REASON FOR UPDATE:

Applications	
Year	2017-2023
Make	Ford
Models	F250/F350/F450 (4WD)

TECH BULLETIN

Installation Guide Update

Diagram 1

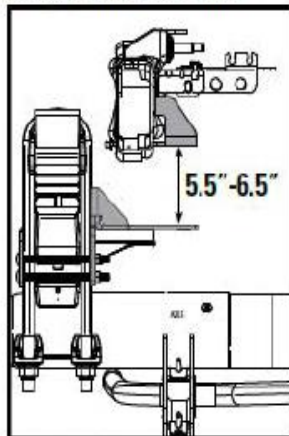
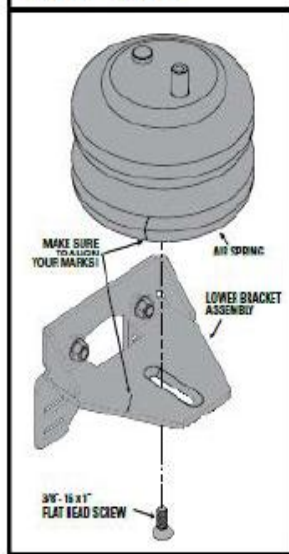
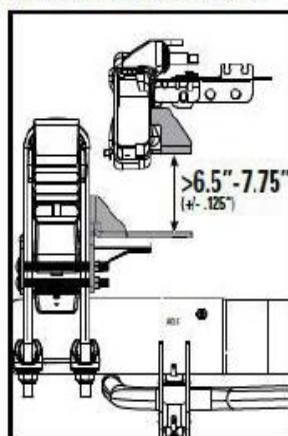
- When securing the air springs to the lower brackets, use part number 3514 (1.0" Flat Head Cap Screws) when the 1.5" spacer (5336) is not being used.
- When using the 1.5" spacer (5336), use part number 3430 (2.0" Flat Head Cap Screw) to secure the air spring to the air springs to the lower brackets.
- Do not use the 1" Flange Bolt (3106) or the 2" Flange Bolt (3150) to secure the air spring to the lower bracket. Using the Flange Bolts will not allow the lower bracket (5938) to sit down on the jounce stop. See "Diagram 1":

Diagram 2

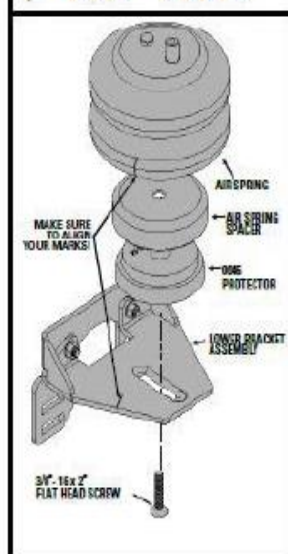
- When installing the lower bracket (5938 or 5948) be sure that the bracket is sitting down on the jounce stop. See "Diagram 2":
